## ADDENDUM NO. 3

TO: PLANS AND SPECIFICATIONS FOR STATE OF MISSOURI

Upgrade Cave Electric  
Onondaga Cave State Park  
Leasburg, Missouri  
PROJECT NO.: X2212-01

SHEET TITLE:  
ABOVE GROUND  
SITE PLAN

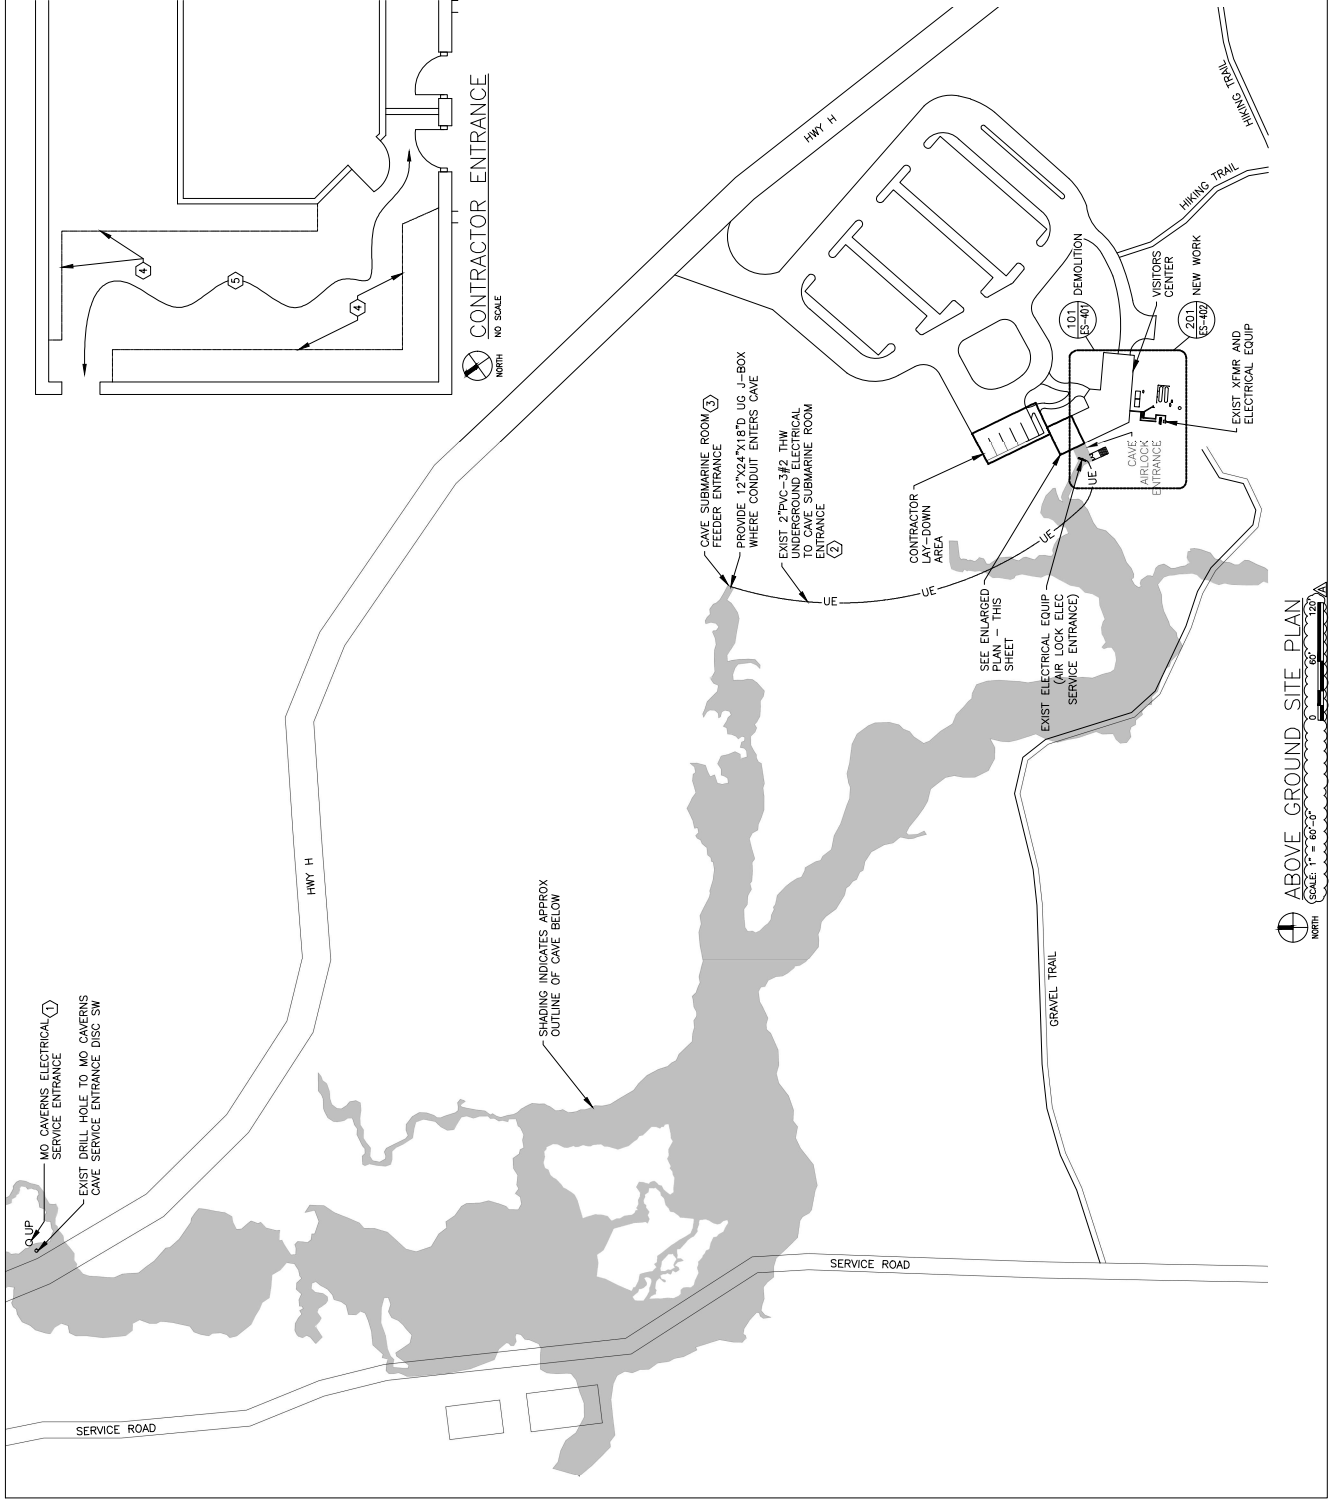
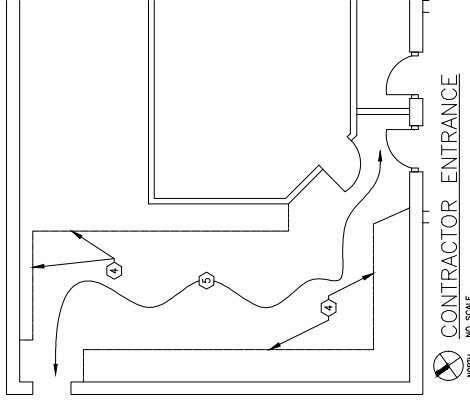
1. Sheet ES-101

- a. REVISE per attached Revision A, dated 08-25-2023.

SHEET TITLE:  
ONE-LINE  
DIAGRAMS (EXIST  
CONDITION)

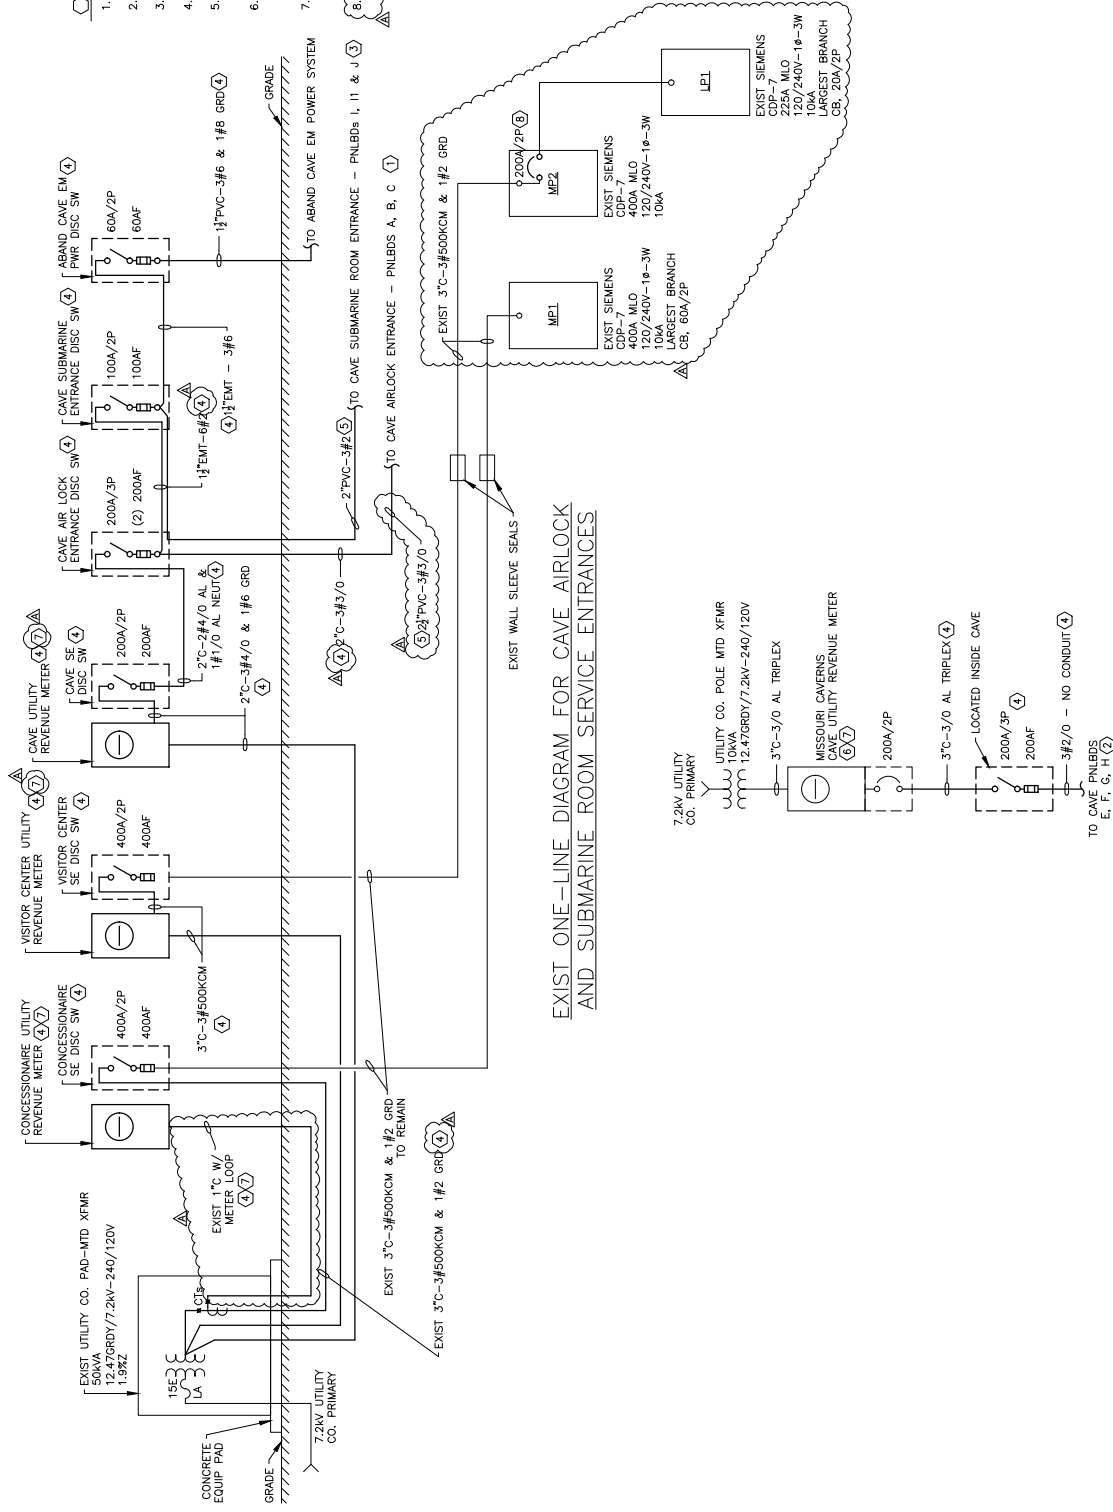
6. Sheet ED-601

a. REVISE per attached Revision A, dated 08-25-2023.

SHEET TITLE:  
CAVE ELECTRICAL  
PLAN - SECTION I

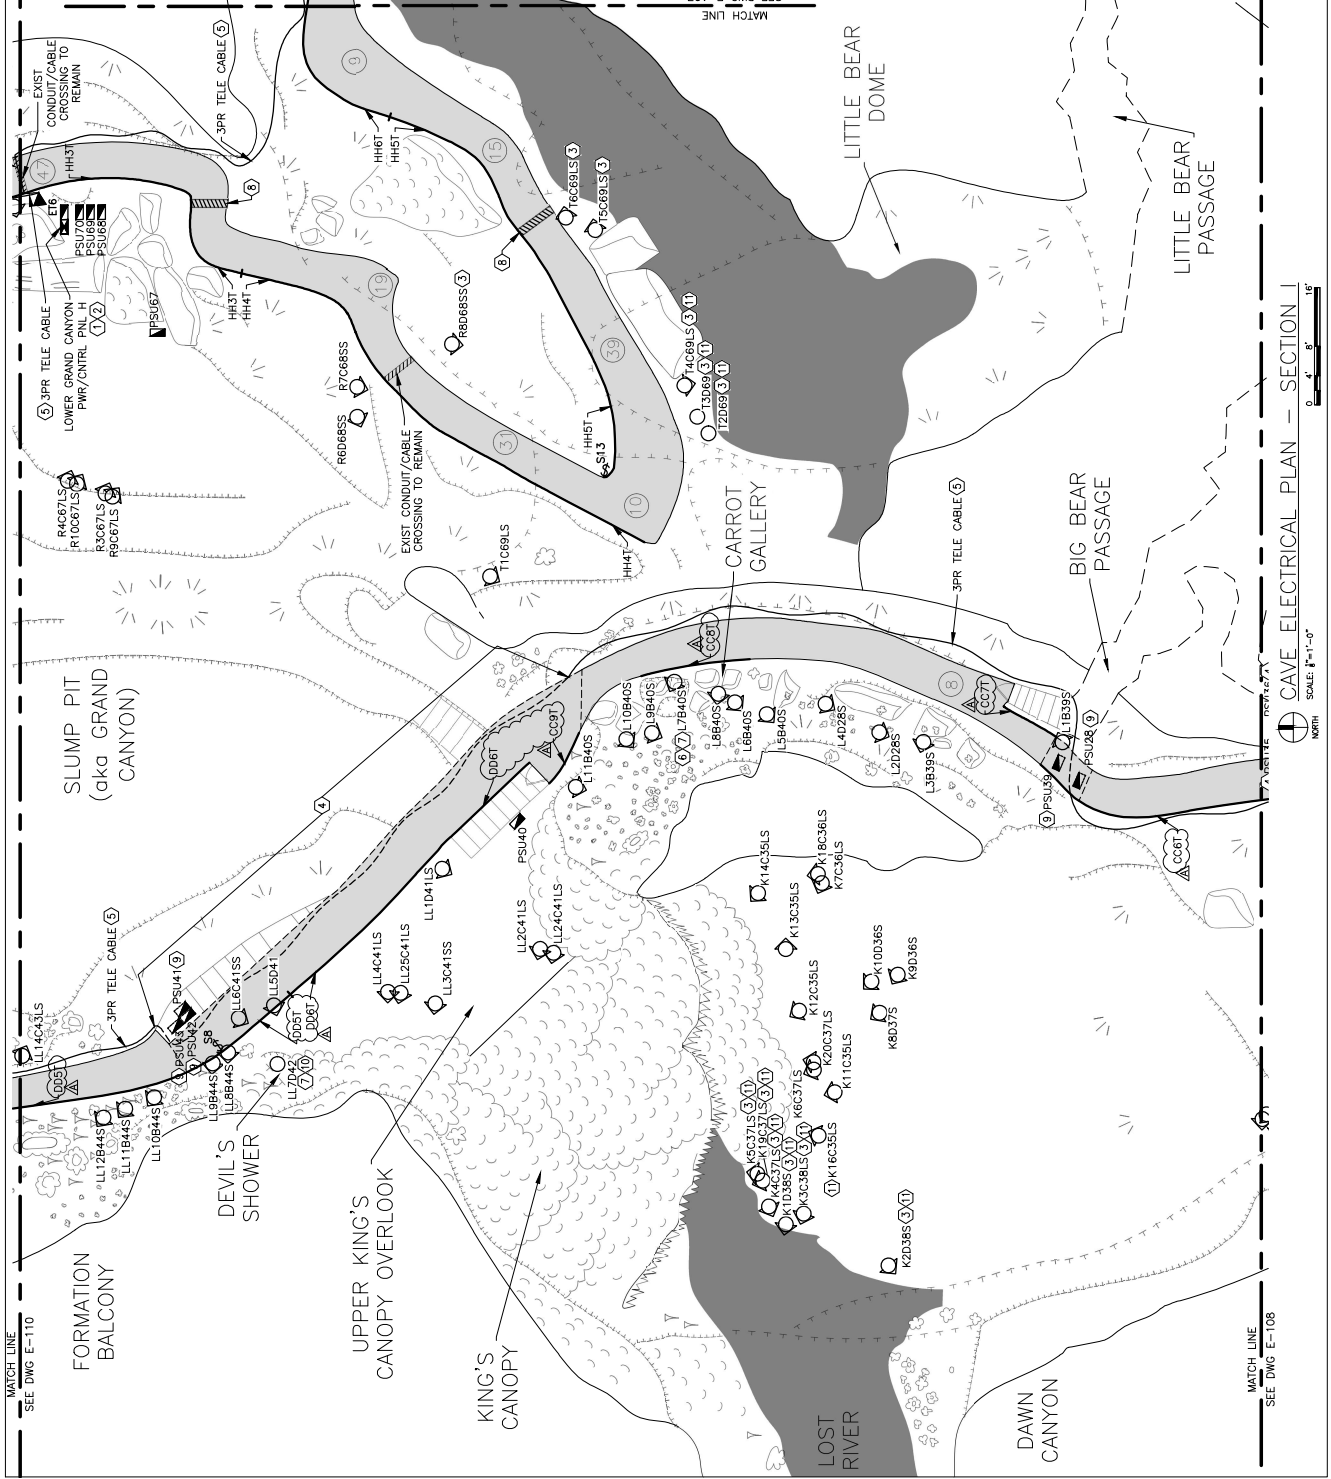
16. Sheet E-110

- a. REVISE per attached Revision A, dated 08-25-2023.

SHEET TITLE:  
ELECTRICAL  
DETAILS

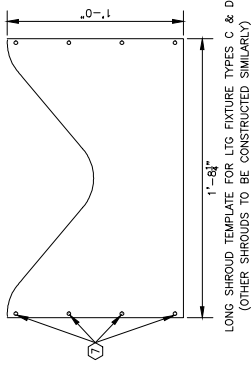
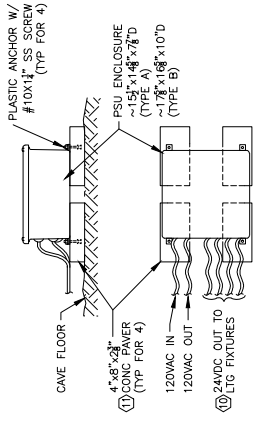
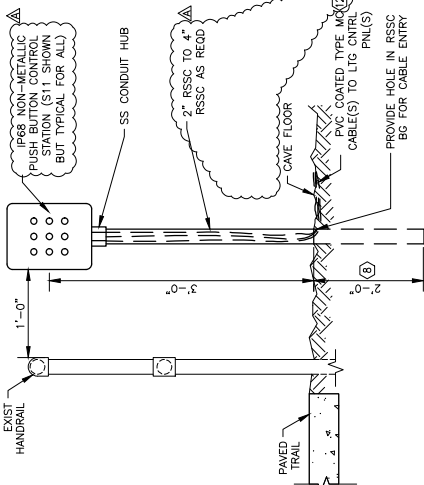
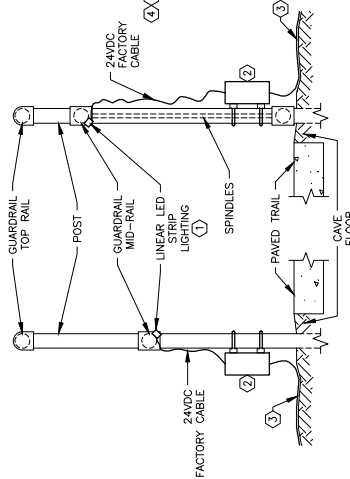
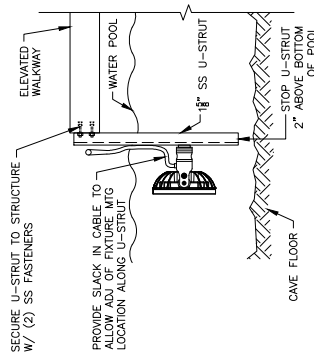
19. Sheet E-501

- a. REVISE per attached Revision A, dated 08-25-2023.
